**TOWN OF MOUNTAIN VILLAGE
SPECIAL DESIGN REVIEW BOARD MEETING
AGENDA**

THURSDAY JUNE 10, 2021 10:00 AM

3.	10:05	45	Miller Applicant	Quasi-Judicial	Consideration of a Design Review: Initial Architecture and Site Review for a new Single-Family home on Lot 226BR, 242 Benchmark Drive, pursuant to CDC Section 17.4.11. This item was continued from the 4.22.2021, and 6.3.2021 Regular Meeting.

RE: Consideration of a Design Review: Initial Architecture and Site Review for a new Single-Family Detached Condominium on Lot AR59, 129 Adams Way, pursuant to CDC Section 17.4.11.

LANDSCAPE PLAN

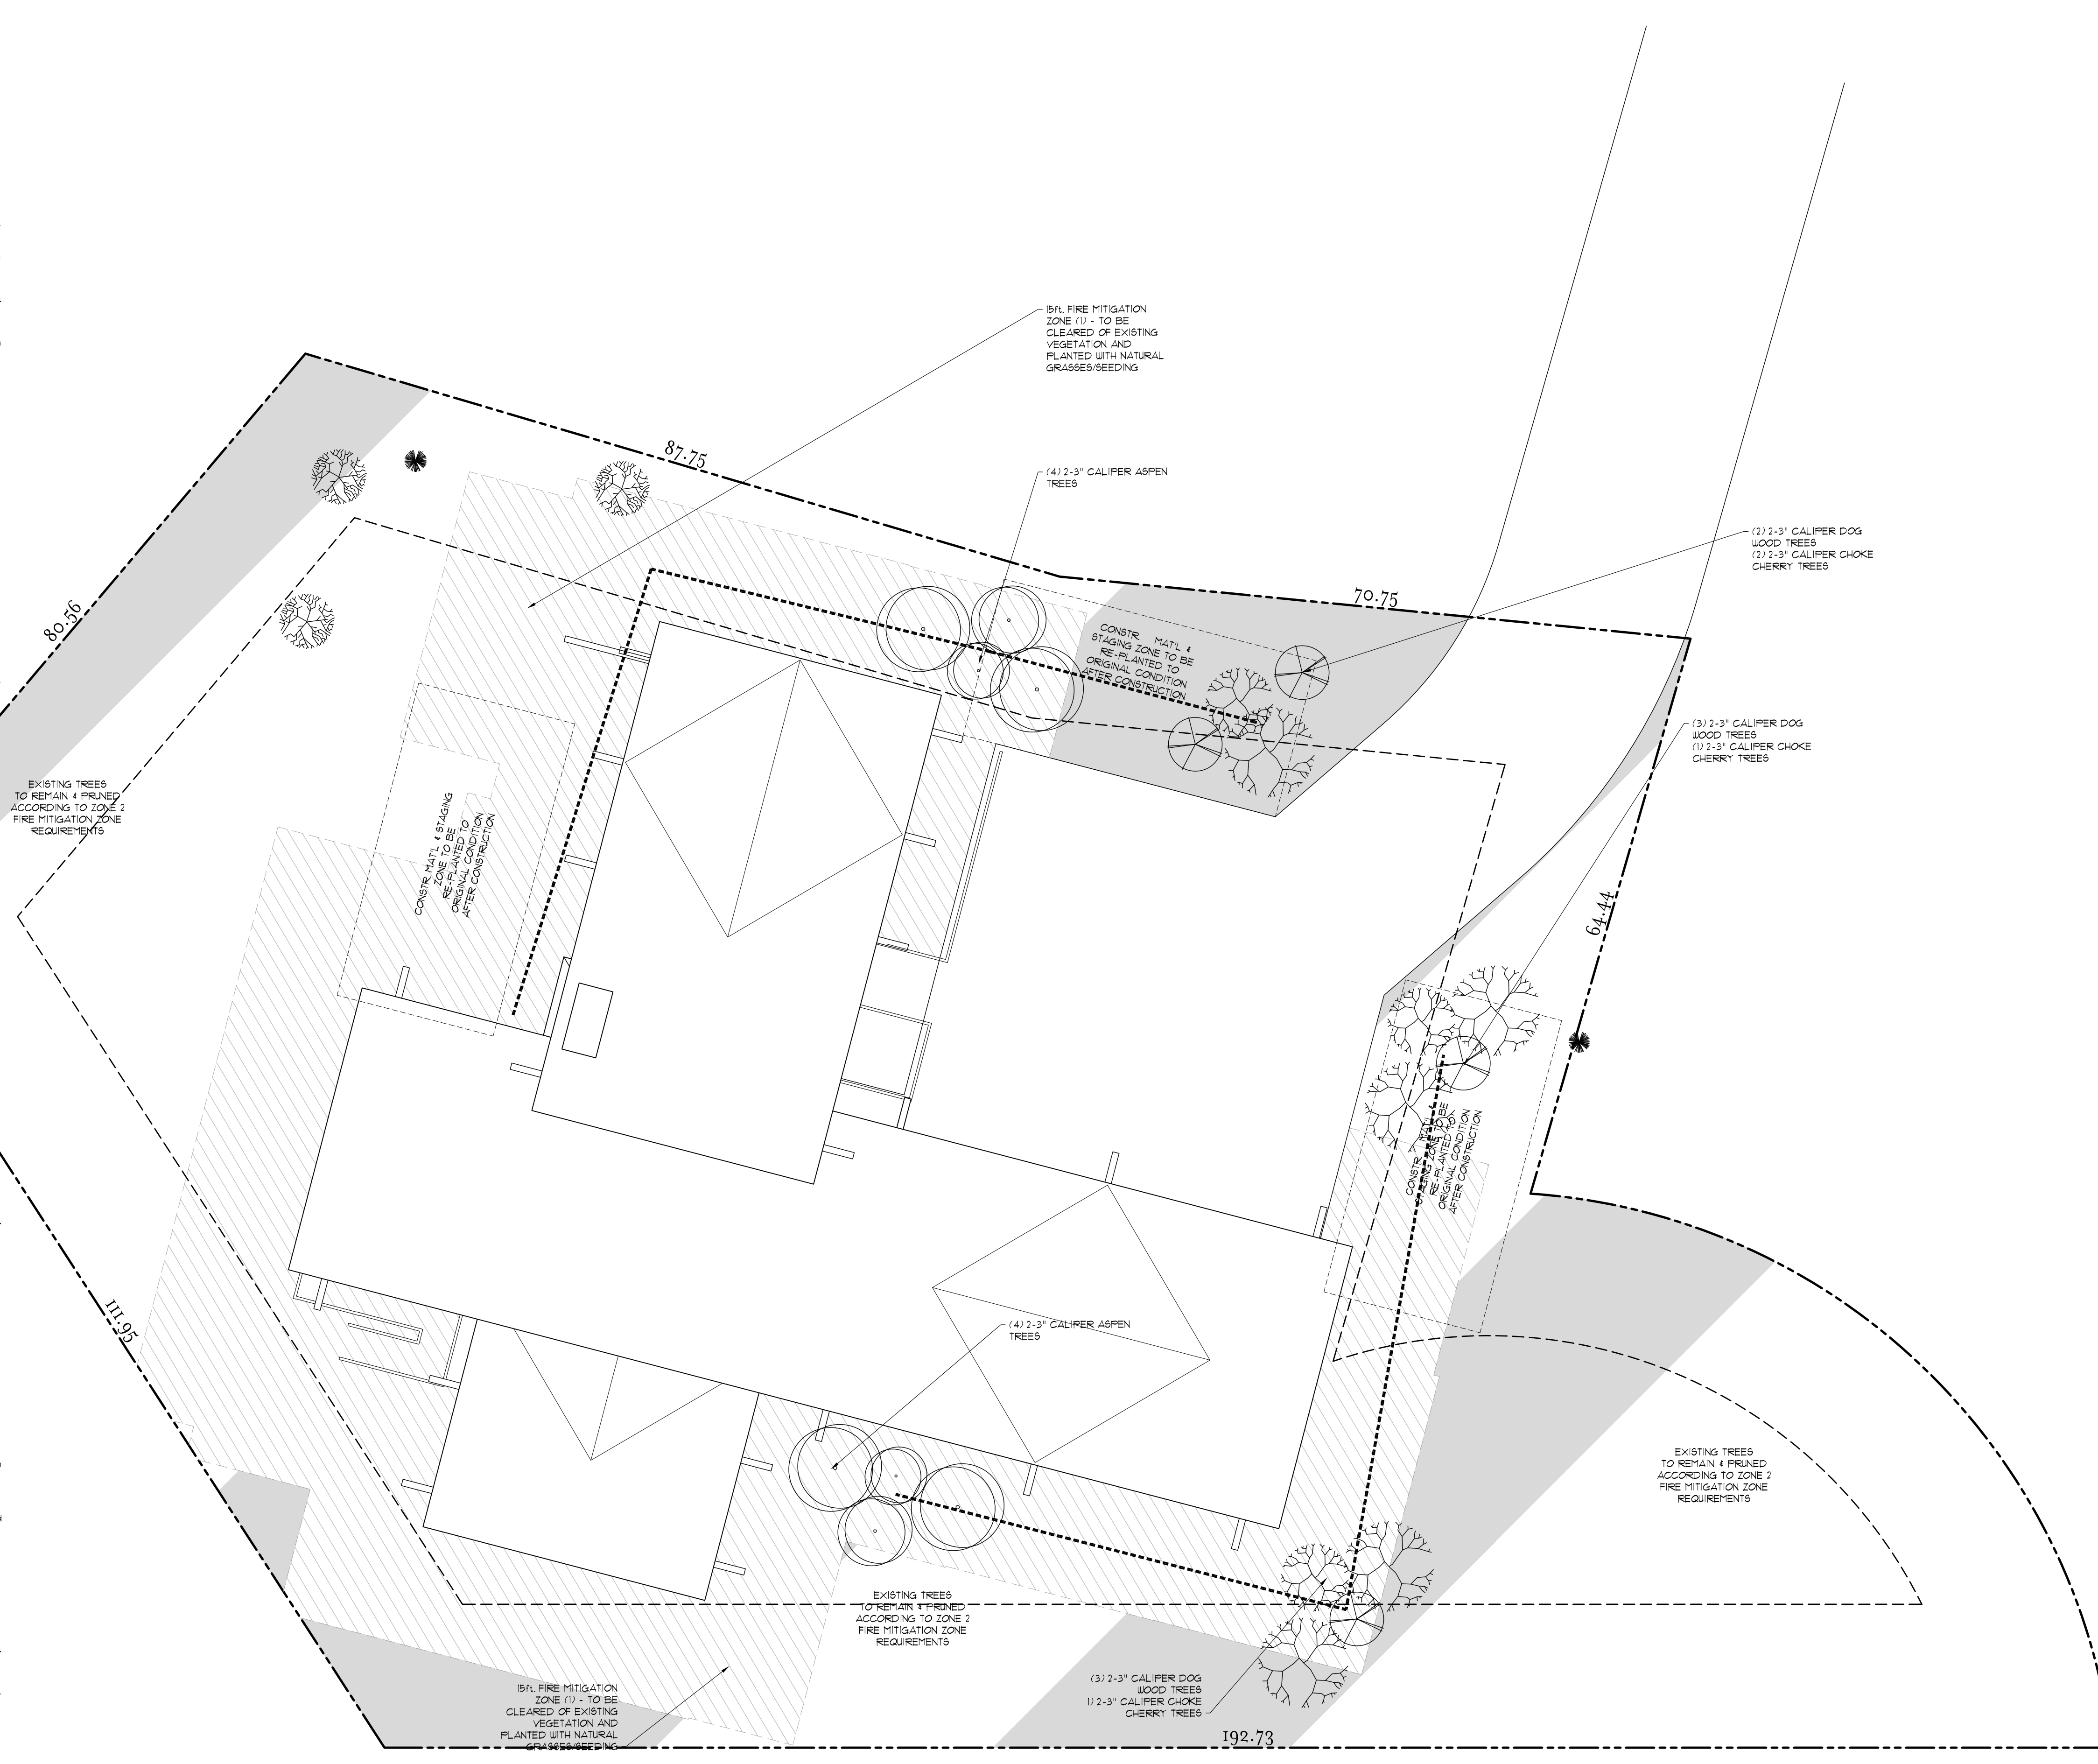
1. *Due to the number of notes on the plan page A1.3, staff recommends separating the landscaping and fire mitigation plans into two separate documents.*
2. *Additional shrub plantings should be provided in addition to the trees identified.*
3. *The applicant could potentially work with neighboring owners to provide additional landscaping buffer along driveway retaining walls.*
4. *Native Seed Mix per the CDC requirements must be identified and any area of disturbance on the site must be identified for revegetation.*
5. *Existing trees on-site to remain shall be identified. If within proximity to construction, they should be protected, and the protection method should be detailed.*
6. *Irrigation notes related to flow usage, backflow preventor, etc. shall be added.*

- 3) Prior to submittal for a Final Architectural Review, the applicant shall provide area calculations for snowmelt.
- 4) Prior to submittal for a Final Architectural Review, the applicant shall revise the landscaping and fire mitigation plan based on the comments within this report.

C2

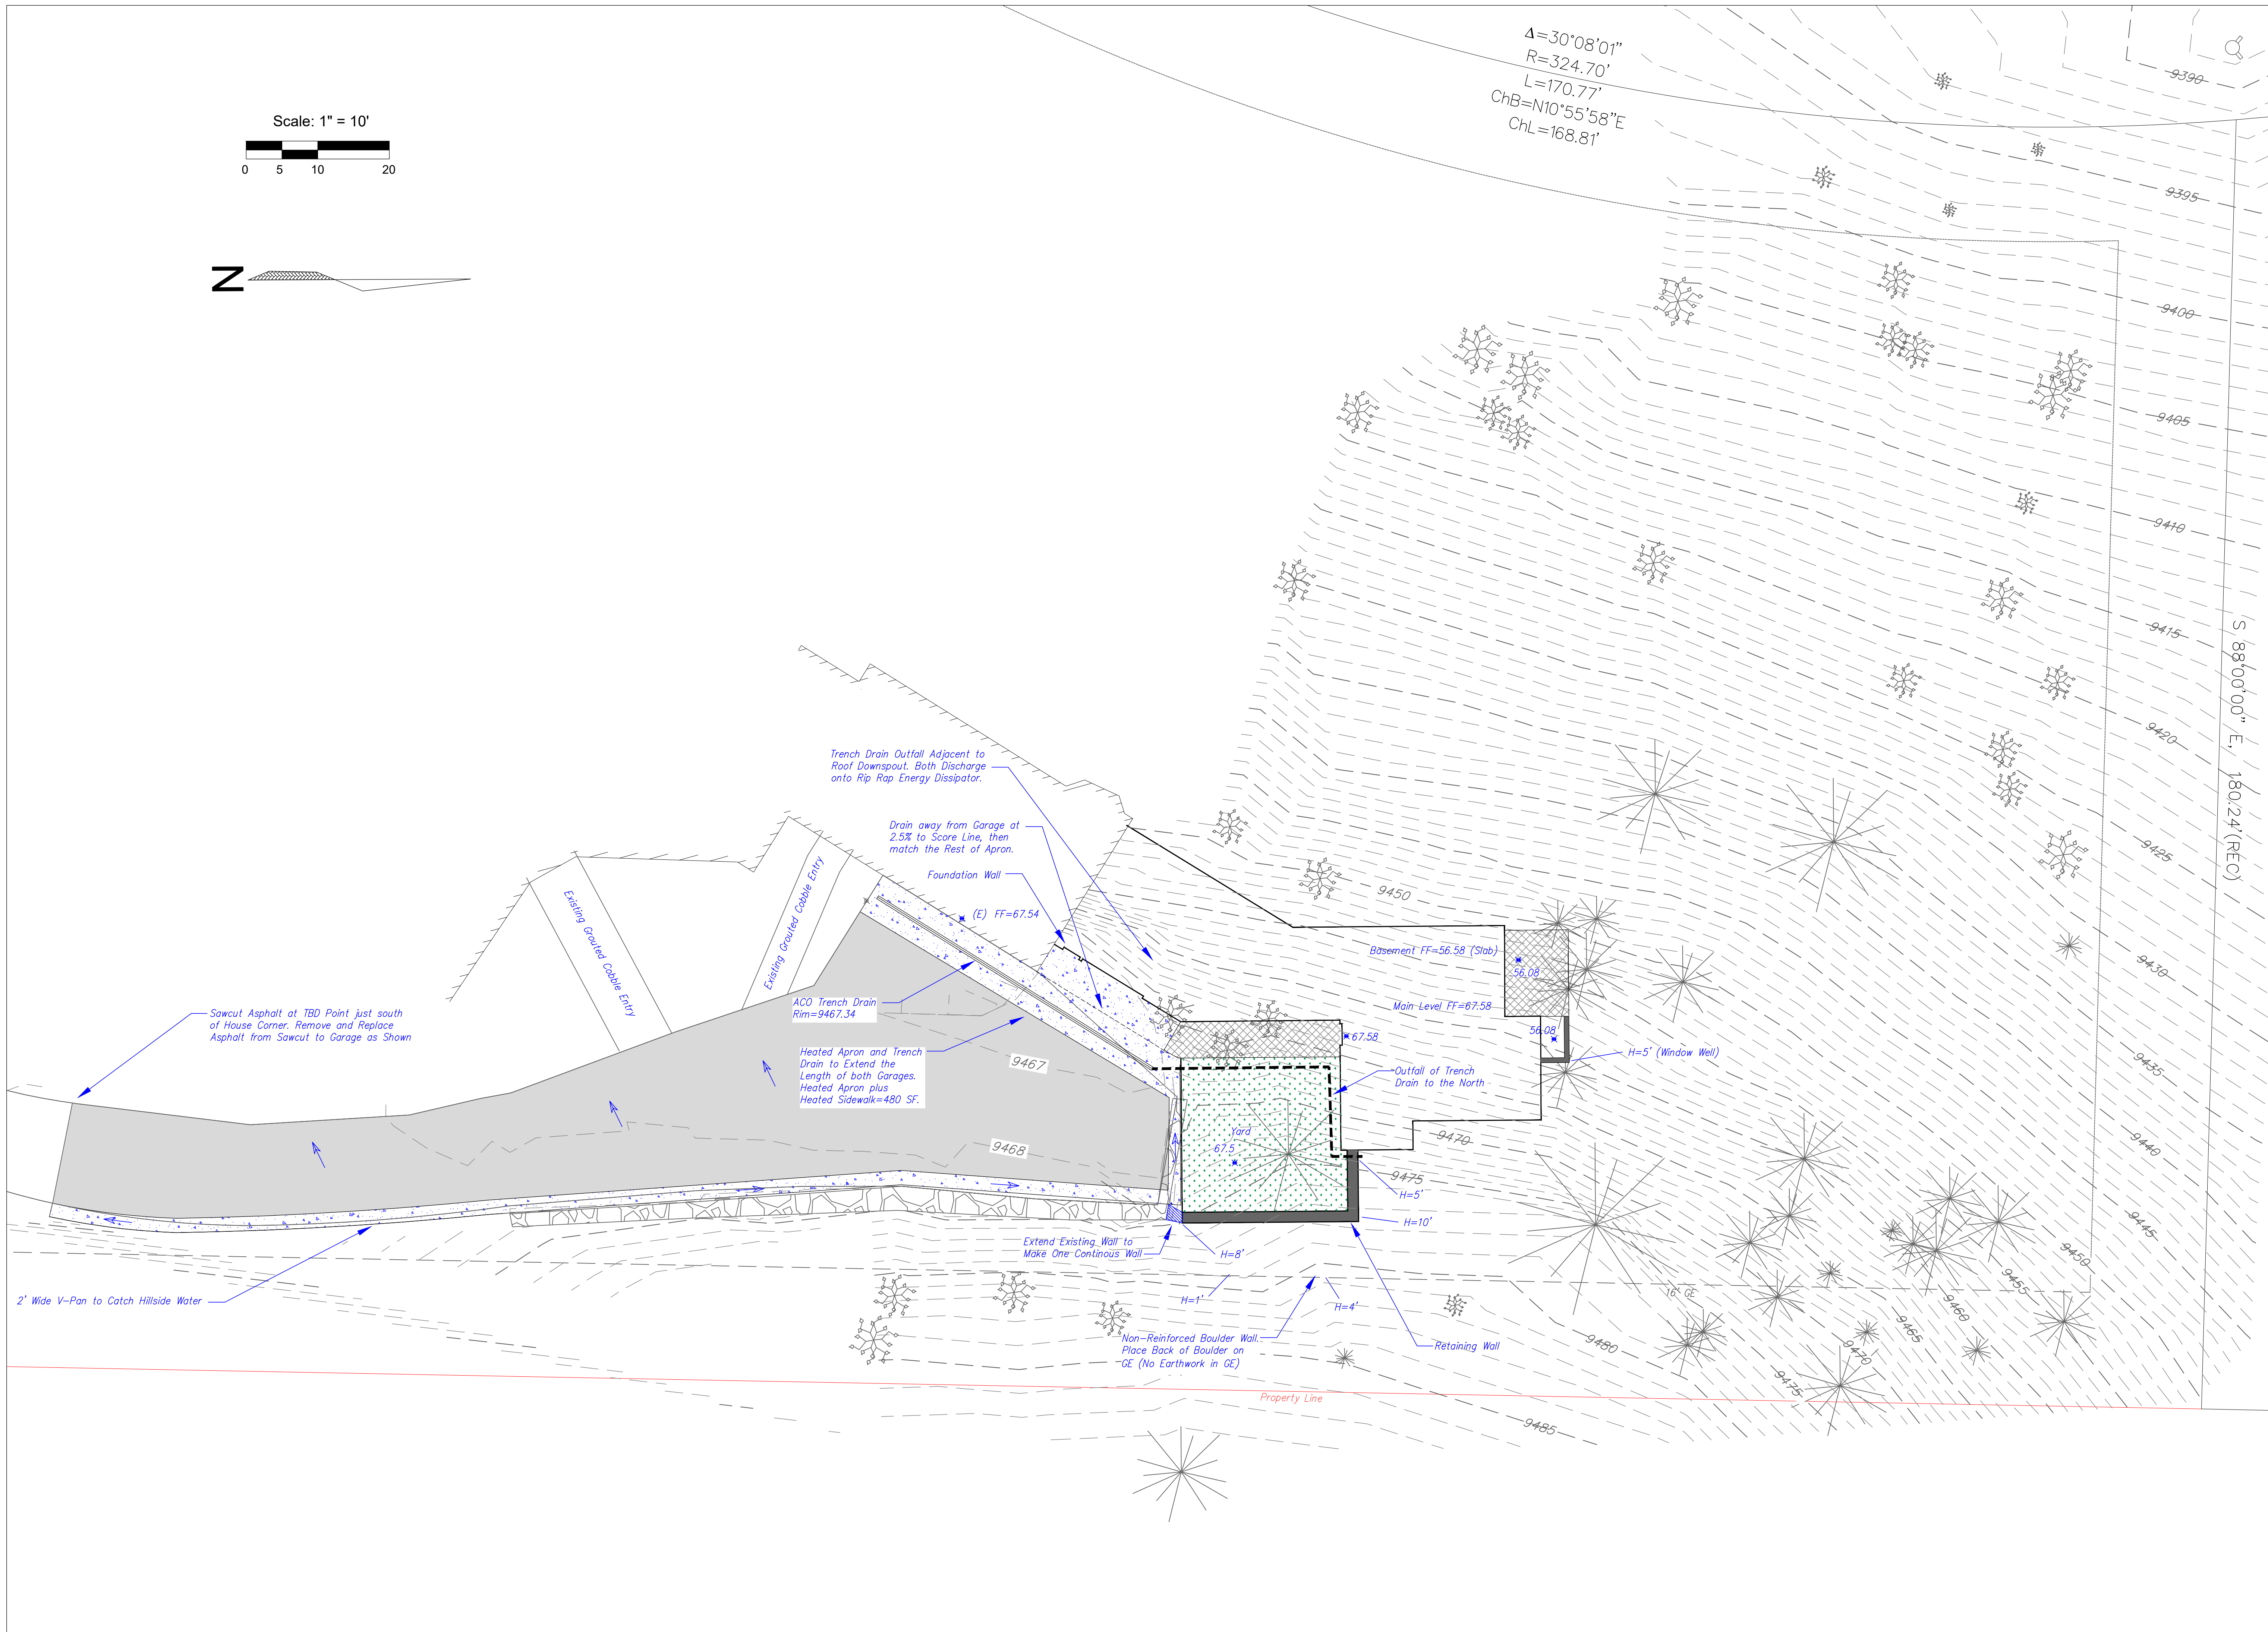
1. Drawing C2 shows a “dry stack wall to divert existing swale” and we respectfully request to remove that wall, and divert the runoff water through Lot 404-A. We are requesting this for the following reasons:

- c. The construction of the dry stack wall would require a variance by itself.
2. Drawing C2 shows a driveway retaining wall 5'-0" high and we respectfully request a Design Variation from the maximum 4'-0" stepped wall requirement.
